Technical Bulletin

Products: Plasma	Models : TH-42PX600 TH-50PX600	Number: TB-06-08
Code: B62	Year: 2006	Date: Dec 12,06

Symptom: Vibration noise from left or right speaker.

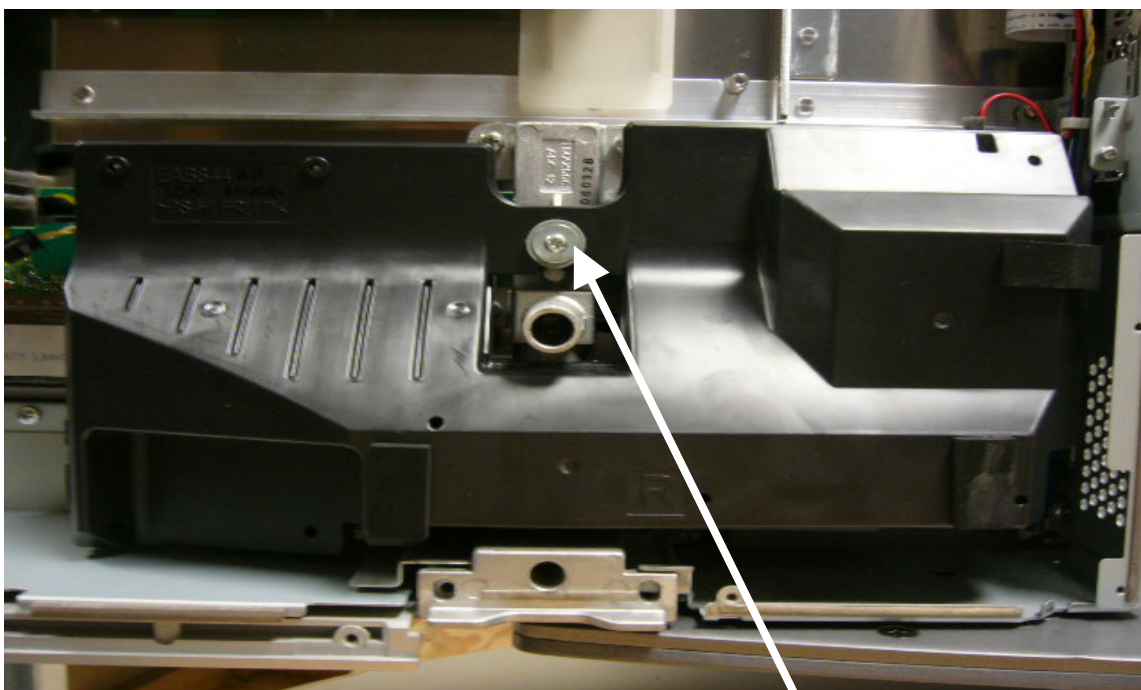
Cause: Speaker box is making direct contact with cabinet parts.

Add screw THEL049.

Remedy: Installing mounting screw in the center of speaker box prevents from touching the cabinet parts and minimizes the risk of vibration noise.

Procedure: Install screw, part number THEL049 to both speaker boxes as in attached picture.

Please repeat the same for left speaker box.
